Access Compliance Report

Public Rights-of-Way

Intersection ID: 21819	Main Street: AUTUMN_BLAZE_DR	Cross Street: POPLAR_FOREST_DR	Location: W
ADA ID: 2BD6C8CEEA16	Ramp Type: BlendTrans2	Initial Pass/Fail: Fail	Overall Compliance: No
		Severity Score: 8.75

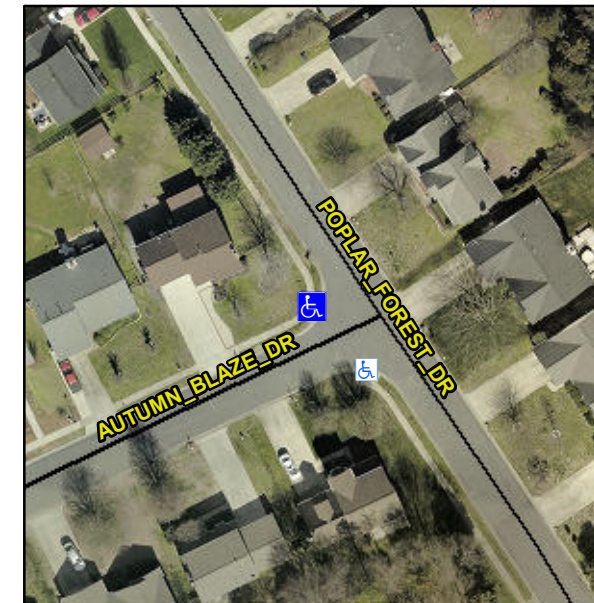
R304.5.1

Compliance	Description	Data	Compliance	Description	Data
N/A	Ramp Length (in)	92.0	Yes	BlendTrans Slope (%)	3.8
No	Ramp Width (in)	36.5	Yes	BlendTrans XSlope (%)	0.1
N/A	Flare Type LT	N/A	N/A	Flare Type RT	N/A
N/A	Flare Slope LT (%)	N/A	N/A	Flare Slope RT (%)	N/A
N/A	Flare Traversable LT?	N/A	N/A	Flare Traversable RT?	N/A
N/A	Landing Length (in)	N/A	N/A	DWS Provided?	N/A
N/A	Landing Width (in)	N/A	N/A	DWS Contrast?	N/A
N/A	Landing Slope (%)	N/A	N/A	DWS Length (in)	N/A
N/A	Landing X Slope (%)	N/A	N/A	DWS Full Width?	N/A
N/A	Landing Curb? (Y/N)	N/A	N/A	DWS Offset (in)	N/A
N/A	Shared Landing?	N/A			
N/A	Gutter Ponding?	N/A	N/A	Gutter Slope (%)	N/A
N/A	Gutter Lip Ht (in)	N/A	N/A	Gutter X Slope (%)	N/A
N/A	Painted X Walk1?	No	N/A	Painted X Walk2?	No
	X Walk 1 Direction	To SE		X Walk 2 Direction	To NE
	X Walk 1 Width (in)	N/A		X Walk 2 Width (in)	N/A
	X Walk 1 Slope (%)	3.7		X Walk 2 Slope (%)	1.5
	X Walk 1 X Slope (%)	1.6		X Walk 2 X Slope (%)	0.3

Remove & Replace Curb Ramp With Two New Directional Ramps or Equivalent.
